WES-2023-107 Response to Reviewers

Figure 12: (a) aerodynamic torque as a function of blade pitch for OpenFAST and QBlade for 11 m/s operating TSR, and relative trendlines. (b) derivative of aerodynamic torque as a function of blade pitch computed from analytic derivative of trendlines.

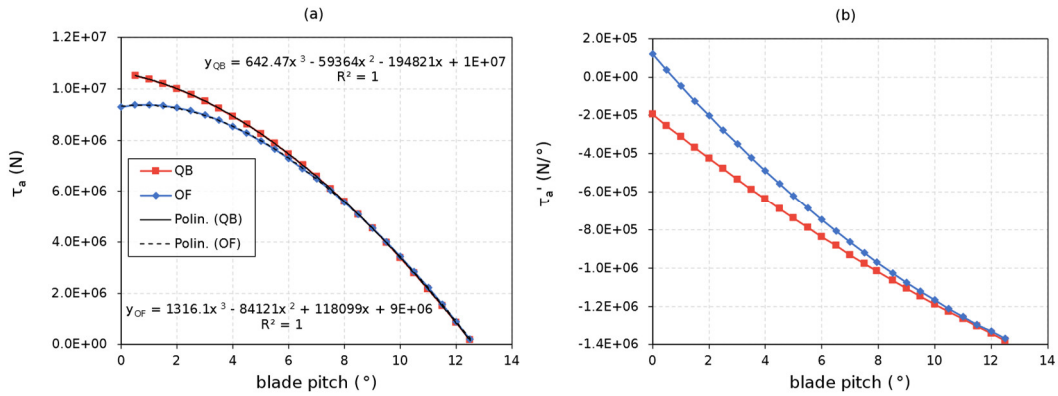
2. The conclusions are, in some aspects, weak. For example, the self-excitation phenomenon (one of the most interesting findings of the paper) is predicted in different way by the codes, but the explanation of the over-estimate of Q-Blade code is demanded to another paper (Behrens de Luna et al.), still unpublished; it could have been a relevant discussion and conclusion also of the present paper. As a second example, the results often show differences between the predictions of OpenFAST and DeepLines Wind, despite the two codes are of the same fidelity level; the explanation of these results are demanded to future studies, while one would have expected such discussion in this paper, for example by resorting to the different structural model of OpenFAST or to the compiling/import issues of DeepLines Wind mentioned in the paper (and see below for the remarks on these aspects).

The Reviewer stressed an important point. The conclusion of this study is indeed different from our initial expectation when we started this work and the FLOATECH proposal was written. Before going into this, we were expecting that the additional motion afforded by the floating installation would accentuate the differences found by many between aerodynamic and structural models for onshore wind turbines. Throughout this study, however, we have mostly found small differences between the compared codes. We have tried to highlight this better in the conclusions (L584-588). Regarding the explanation of the self-excitation phenomenon, the paper by Behrens de Luna et al. that we referenced is part of the same work that led to this paper. Based on the reviews we received on both papers, we have decided to change the title of both works to link them together and hopefully improve clarity and scope of both works. Based on the intuition in that paper, we have run additional analyses in OpenFAST and QBlade to shed some light on the possible causes of the phenomenon. Various physical phenomena could, in principle, cause such a difference in excitation. However, by process of exclusion, differences in hydrodynamic excitation are unlikely to be the cause of the increased self-excitation in QBlade, as nearly identical response in QBlade and OpenFAST was noted at the Softwind's pitch natural frequency in part one of this study ([3], Fig. 13). Moreover, the aerodynamic model is also not the cause, as switching to DBEM in QBlade did not improve agreement in this regard with respect to OpenFAST (not shown herein for brevity). As stated previously, OpenFAST doesn't include blade torsion. However, switching to a rigid structure did not improve the agreement of OpenFAST and QBlade. A possible explanation for the difference in blade pitch – platform pitch self-excitation was put forward in part one of this study [3] and is related to increased aerodynamic torque variation in QBlade with respect to the other two codes. Indeed, upon further investigations, differences in the system dynamics, and how they interact with the control system, could explain the observed behavior. As explained in detail by Abbas et al. [2], the controller and turbine can be seen as a closed-loop second-order system, characterized by a natural frequency at a certain operating wind speed:

$$\omega^2 = k_i(U_{op})B = k_i(U_{op})\frac{N_g}{J}\frac{\partial\tau_a}{\partial\beta} \quad (1)$$

where N_g and J are the gearbox ratio and rotor inertia, which are the same in OpenFAST, QBlade, and DeepLines. The higher the natural frequency, the more responsive the system is to an external disturbance such as a platform pitch oscillation. The integral controller gain k_i is also the same in the two codes, as it depends on the controller tuning. The slope of the aerodynamic torque as a function of blade pitch is, however, different in the two codes. The derivative of aerodynamic torque as a function of blade pitch for the mean 11 m/s operating conditions is shown in Fig. 12 (b). As $\frac{\partial\tau_a}{\partial\beta}$ is larger in magnitude for QBlade at the mean operating blade pitch of approximately 0.5° , from eq. 1, ω^2 is also larger, leading to increased self-excitation in QBlade.

This explanation is now included in the paper (L495-518).
